## **Wilson Creek Energy Corp.**

### **Wilson Creek Power Plant and Connection Order**

Decision 27249-D01-2022

Proceeding 27249

Figure 2. Noise study area

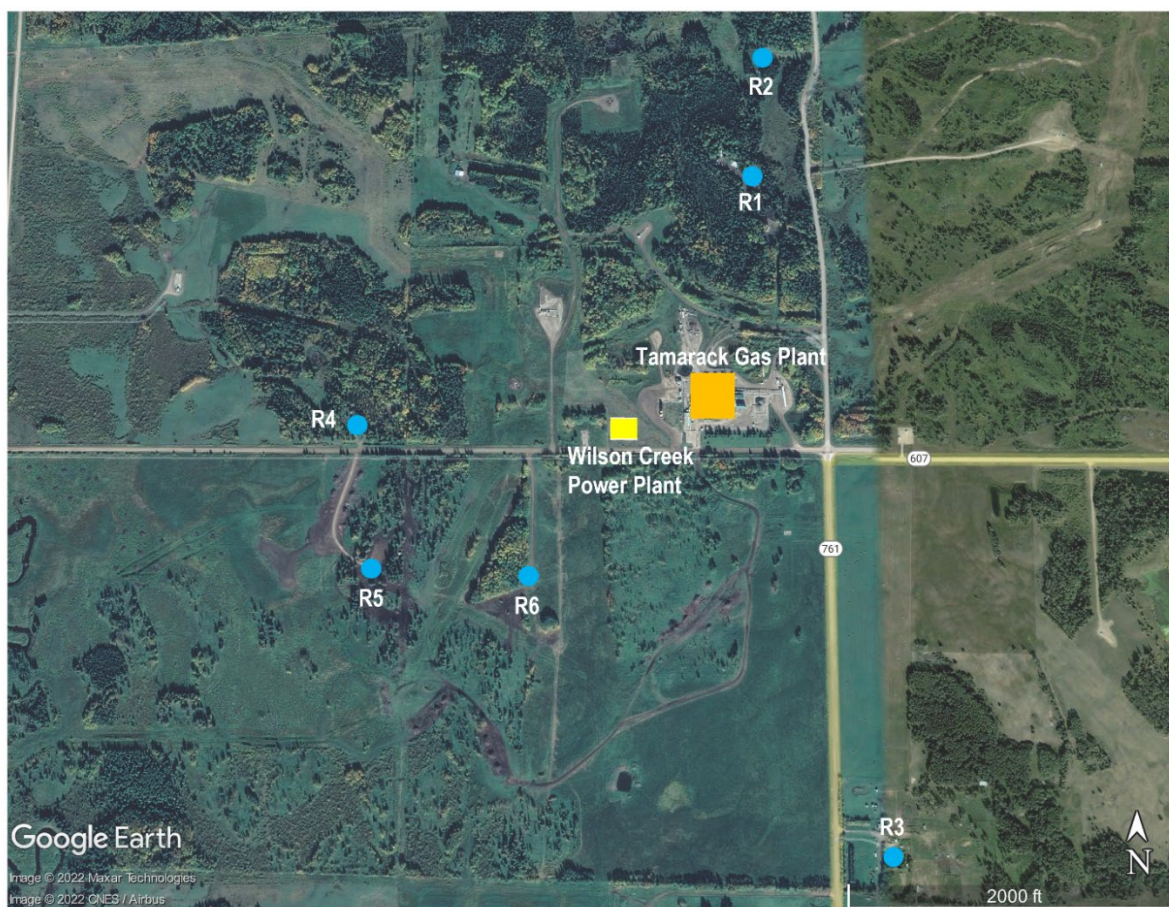
11. The NIA determined the applicable permissible sound levels (PSLs) to be 40 A-weighted decibels (dBA) nighttime and 50 dBA daytime at receptors R1 through R5. The NIA indicated that Receptor R6 was constructed after the existing Tamarack Gas Plant. Consequently, Receptor R6 is considered a new dwelling in the context of Rule 012, and the applicable nighttime PSL at Receptor R6 is 44 dBA because this was the sound level existing at the time the dwelling was constructed.<sup>8</sup>

15. The NIA considered Receptor R6 a new dwelling with respect to the existing Tamarack Gas Plant because it was built after development of the most recent noise model for the Tamarack Gas Plant in 2016 (2016 model). WCEC clarified that the Tamarack Gas Plant received approval from the Alberta Energy Regulator (AER) in 2015, while according to the information from Ponoka County, Receptor R6 was built in 2021. WCEC further clarified that the 2016 model was built to verify post-construction noise emissions from the Tamarack Gas Plant.<sup>9</sup>

16. Rule 012 defines "new dwelling" as "A dwelling that is built after submission of the noise impact assessment for a proposed facility (i.e., a circumstance in which the noise impact assessment does not present modelled cumulative sound levels at the new dwelling)." Based on this definition, the Commission finds that Receptor R6 is a new dwelling relative to the existing Tamarack Gas Plant.

20. The NIA used the 2016 model to establish the sound level at Receptor R6 at the time this dwelling was being constructed. Based on the 2016 model, the sound level at Receptor R6 at the time of construction was 43.7 dBA, which is greater than the PSL of 40 dBA established in Section 2.1 of Rule 012. Because PSLs are typically expressed as whole numbers, the NIA used 44 dBA (i.e., 43.7 dBA rounded to the nearest whole number) as the nighttime PSL applicable at Receptor R6.<sup>12</sup>

21. As part of the NIA, a noise model was developed to represent conditions as they would exist once the project commences operations (2021 model). The 2021 model was used to predict cumulative sound levels at noise receptors R1 through R6. The 2021 model predicted the nighttime cumulative sound level at R6 will be 42.3 dBA, which is less than the 43.7 dBA sound level predicted using the 2016 model. In other words, the NIA predicted that development of the proposed project (i.e., addition of project buildings and equipment to the existing environment) will reduce the cumulative sound level at Receptor R6 relative to the sound level predicted by the 2016 model.

22. dNCL explained that the cumulative sound level predicted for Receptor R6 using the 2021 model is less than the sound level predicted using the 2016 model because:<sup>13</sup>

- The proposed Wilson Creek Power Plant building would partially block noise propagation from the existing Tamarack Gas Plant to Receptor R6.
- The 2021 model includes acoustically absorptive elements that were not considered in the 2016 model (e.g., natural foliage and detailed ground cover).

23. The Commission notes that the existing Tamarack Gas Plant is a dominant sound source at nearby receptors and is predicted to contribute more noise than the project.<sup>14</sup> Because the proposed power plant will be located between the existing Tamarack Gas Plant and Receptor R6, the Commission finds it reasonable to expect that project buildings will partially screen noise propagation to this receptor. The 2021 model is a higher fidelity noise model as it considers absorptive elements not used in the 2016 model, which provides for a higher accuracy prediction of noise propagation. As such, the Commission finds that it is reasonable to expect the cumulative sound level at Receptor R6 following development of the project will be less than the sound level predicted using the 2016 model.

24. The Commission finds the NIA correctly established the nighttime PSL at Receptor R6 in a manner consistent with both Directive 038 and Rule 012. Accordingly, the Commission accepts that the applicable nighttime PSL at Receptor R6 is 44 dBA.

- b. Wilson Creek Energy Corp. shall conduct a post-construction comprehensive sound level survey, including an evaluation of low frequency noise, at receptors R1, R5 and R6. The post-construction comprehensive sound level survey must be conducted with all generating units operating simultaneously at full capacity and in accordance with Rule 012: *Noise Control*. Within one year after the project commences operations, Wilson Creek Energy Corp. shall file a report with the Commission presenting measurements and summarizing results of the post-construction comprehensive sound level survey.
